SUBJECT: SHEARON HARRIS NUCLEAR POWER PLANT, UNIT 1 - ISSUANCE OF AMENDMENT REGARDING PRESSURE/TEMPERATURE LIMITS (TAC NO. MA8642)

AMENDMENT NO. 100 TO FACILITY OPERATING LICENSE NO. NPF-63 - HARRIS, UNIT 1

Amendment No. 100
License No. NPF-63

SAFETY EVALUATION BY THE OFFICE OF NUCLEAR REACTOR REGULATION

FIGURE 3.4-2
REACTOR COOLANT SYSTEM
COOLDOWN LIMITATIONS – APPLICABLE TO UP TO 36 EFPY

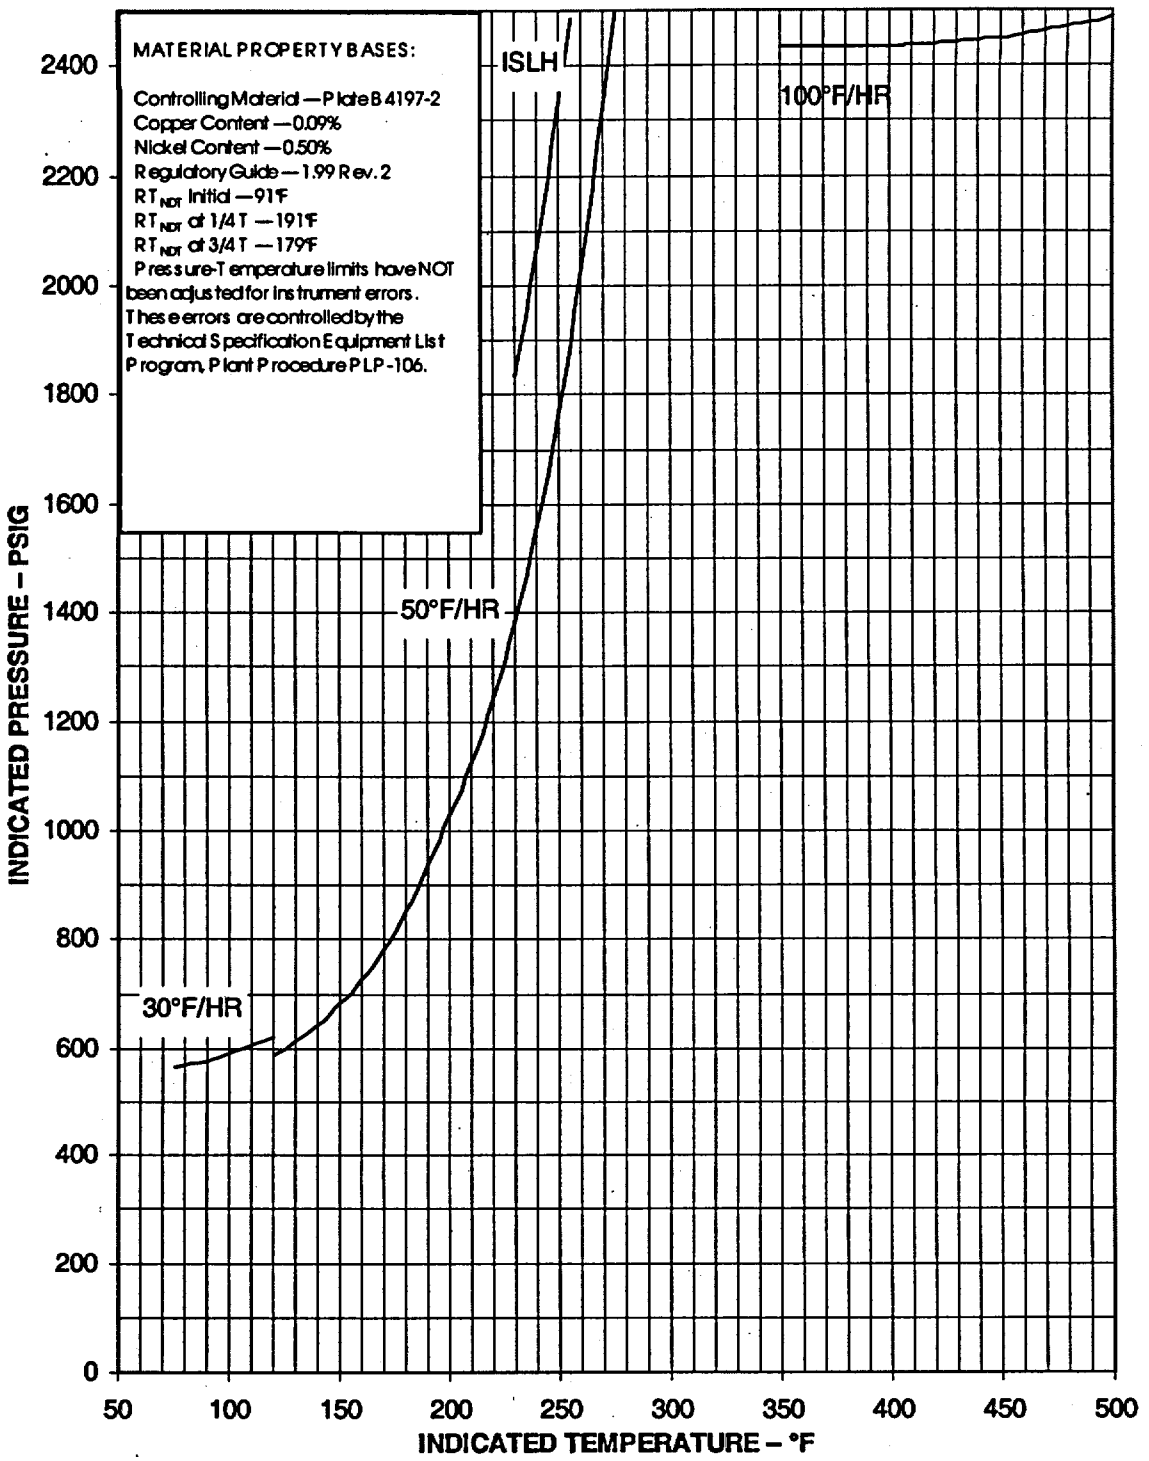
The staff performed check calculations to verify the P-T limit curves using the appropriate limiting ART values for the HNP RPV beltline materials. The staff found good agreement with the submitted P-T curves, as calculations confirmed various points on the submitted P-T limit curves within a few degrees of indicated temperature. The staff also found that the minimum temperature requirements of Table 1 of Appendix G to 10 CFR Part 50 were properly implemented in the P-T limit curves.

The staff concludes that the proposed P-T limit curves for the reactor coolant system (RCS) for heatup and cooldown satisfy the requirements in Appendix G to Section XI of the ASME Code, as modified by Code Case N-640, and Appendix G of 10 CFR 50, for 36 EFPY. The proposed P-T limit curves also satisfy GL 88-11 because the method in RG 1.99, Rev. 2, was used to calculate the ART. Hence, the proposed P-T limit curves are acceptable for incorporation in the HNP TS.

The cooldown and heatup curves in TS Figures 3.4-2 and 3.4-3 are changed to reflect the new limits. The heatup curve is now limited to a single heatup rate of 50°F/hr. The cooldown curve is reduced to two segments of 50°F/hr and 30°F/hr, respectively.

FIGURE 3.4–4

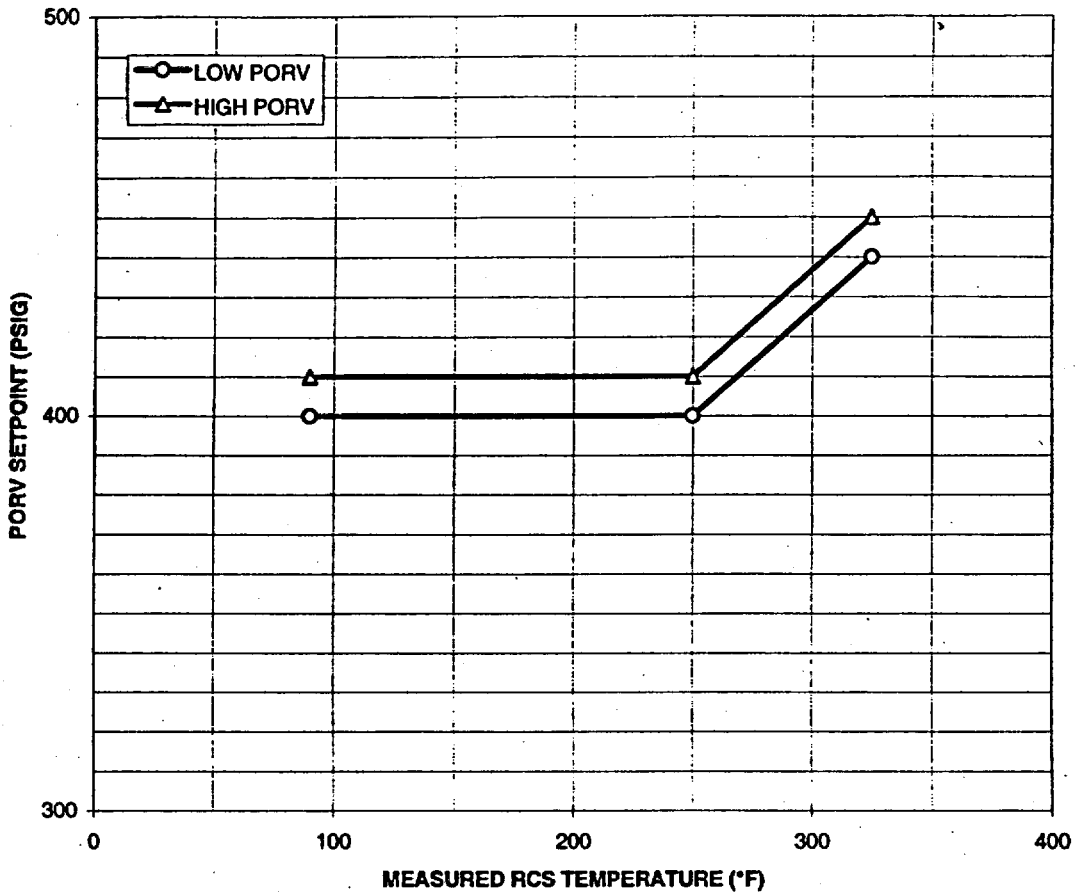
The PORV setpoints are credited for RCS temperatures at or above 90°F. The corresponding PORV settings are: for temperatures <250°F, the setpoints are 400/410 psig low/high, respectively; for temperatures between 250°F and 325°F, the setpoints change linearly from 400/410 psig low/high to 440/450 psig low/high, respectively; for temperatures above 325°F, the pressure can assume any value up to 2400 psig. For heatup between 90°F and 125°F, the new heatup rate is 50°F/hr and the corresponding pressure limit is 563 psig. For cooldown between 90°F and 125°F, the new cooldown rate is 30°F/hr and the corresponding pressure limit is 566 psig. The enable temperature did not change from 325°F.

At the above setpoints, the peak RCS pressure that occurs after the PORV has opened at the setpoint is less than the allowable pressure for the limiting heatup or cooldown transient. This accounts for instrument uncertainties, response times, and PORV flow discharge capacities. The proposed TS changes are, therefore, acceptable.

FIGURE B 3/4.4-1
FAST NEUTRON FLUENCE (E>1MeV) AS A FUNCTION OF FULL POWER SERVICE LIFE

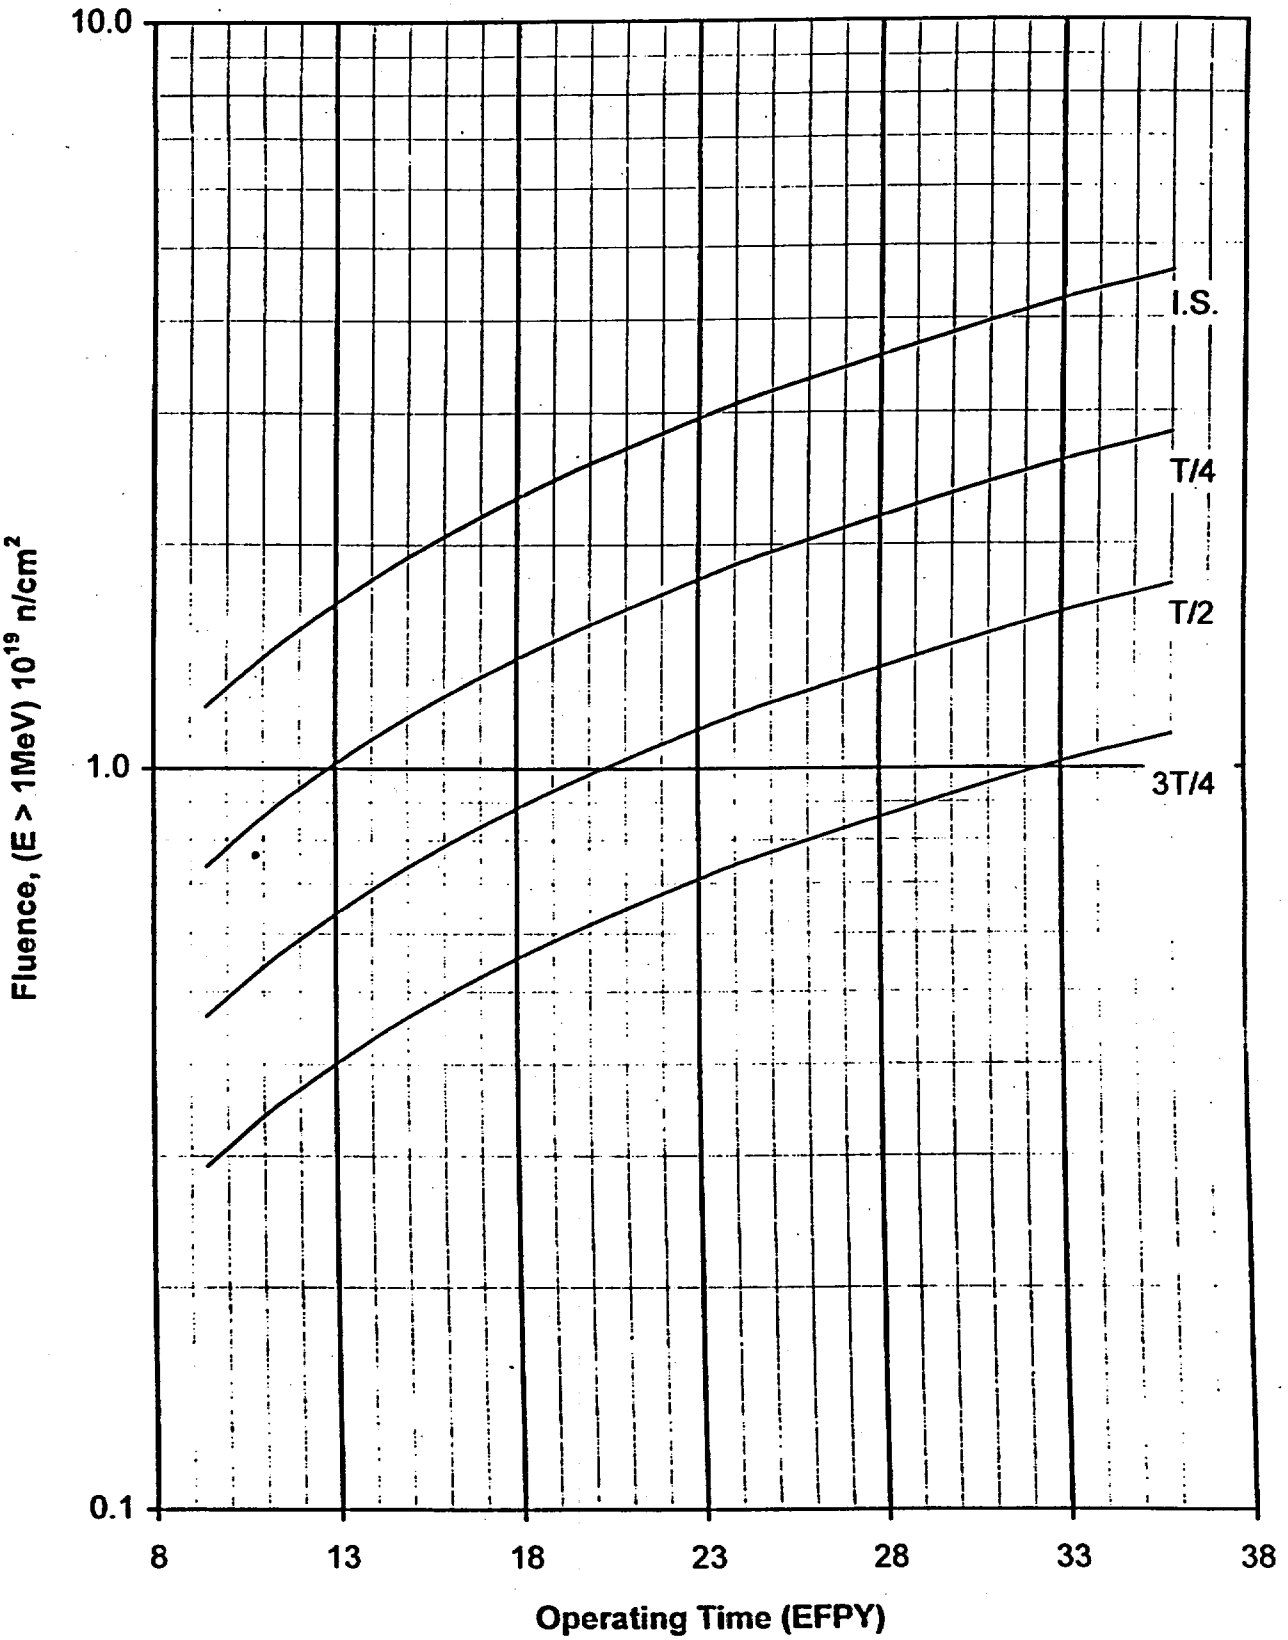
TS Figure B 3/4.4-1 has been replaced to reflect the extended period of operation to 36 EFPY and the surveillance capsule X dosimetry results. These results are also acceptable because they reflect an updated projection of the vessel fluence.
